Application for Licence Amendment

Licence Number	L7391/1999/6
Licence Holder	A. Richards Pty Ltd
ACN	008 734 852
File Number	DEC3864/1
Premises	Richgro, Nowergup Site 206 Wesco Road NOWERGUP WA 6032 Legal description – Part Lot 12738 on Plan 193226 As defined by the coordinates in Schedule 1 of the Revised Licence
Date of Report	10 October 2023
Decision	Revised licence granted

DWER Response Letter – Licence L7391/1999/9 Amendment

Figure 1: Map of groundwater monitoring bore locations (shown in blue)

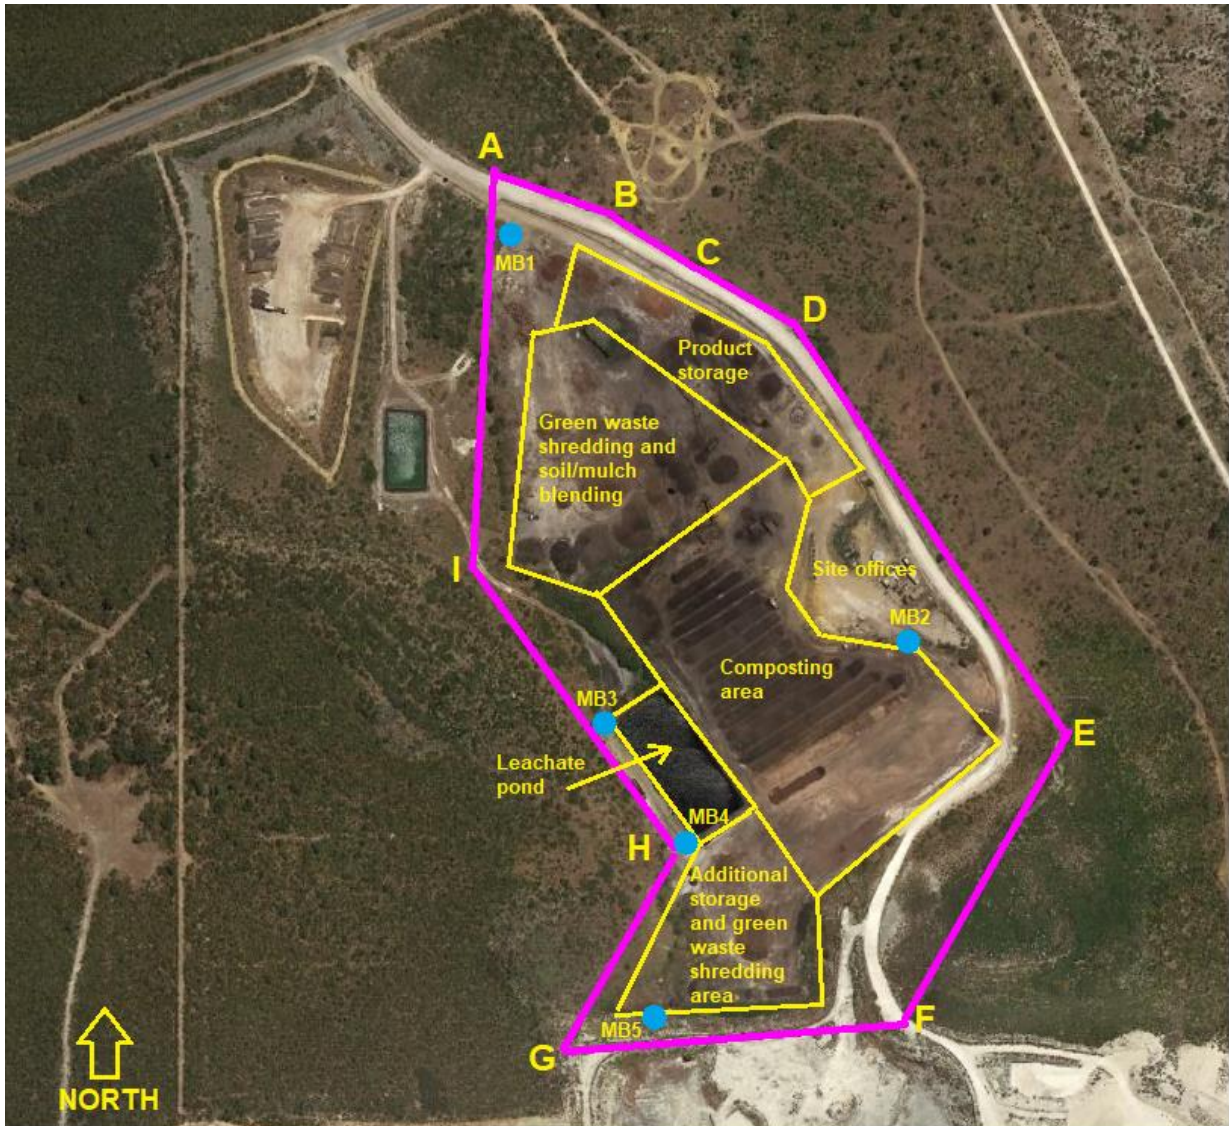
Three groundwater monitoring events have been conducted since the removal of high-risk feedstocks from the premises in November 2022. The results from these monitoring events show no change in concentration of nitrogen compared to previous events in MB4, with total nitrogen reporting the second highest concentration since July 2019 and slight decreases in total nitrogen in MB3. Results also show that MB3 and MB4 are more saline than upgradient wells with total dissolved solids concentrations of 1100 to 1200 mg/L compared to 350 to 690 mg/L in upgradient wells. A map of groundwater monitoring bore locations is presented below in Figure 1.

Aerial imagery of the premises since November 2022 shows significant pooling of leachate on the composting hardstand and similarly the V-drains leading to the leachate pond appear to be full and overflowing. Pooling of leachate is related to the storage and blending of compost products on the premises and suggests that, despite the removal of high-risk putrescible feedstocks in November 2022, there may be an ongoing source of nitrogen contamination.

Surface water monitoring of the pools of leachate on the hardstand and leachate pond was undertaken in May 2023. Concentrations of total nitrogen were shown to be significantly higher in the leachate pools compared to the leachate pond (24 mg/L and 4.3 mg/L respectively). The results indicate that elevated concentrations of nitrogen in groundwater are likely associated with the pooling of leachate on the composting facility's permeable limestone hardstand rather than the leachate pond.
